Ref: 19038 (18)

RE: NZTA – Beaumont Bridge Contaminated Land Technical Review

3.2 Preliminary Site Investigation – Peer Review Comments

Figure 3: 1963 aerial image showing railway yard overlaid with Overall Site Layout Plan. Image sourced from retrolens.nz and licensed for reuse under LINZ CC BY 4.0.

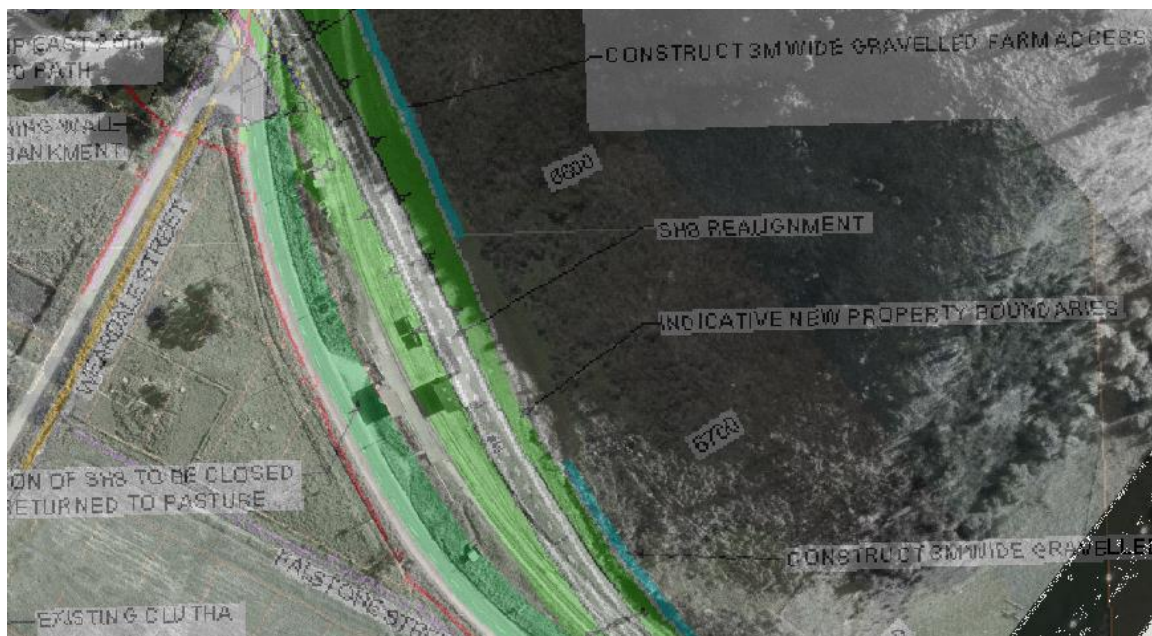
Risk associated with the railway line: Contrary to statements in the PSI, the Overall Site Layout Plan (RP 5615-6200) shows that the realigned State Highway passes directly through the former Beaumont Railway Station and sidings (See Figure 3). This activity fits within HAIL category F6: Railway yards including goods-handling yards, workshops, refuelling facilities or maintenance areas. Potential contaminants associated with this category include: hydrocarbons, solvents, creosote/phenols, and metals.
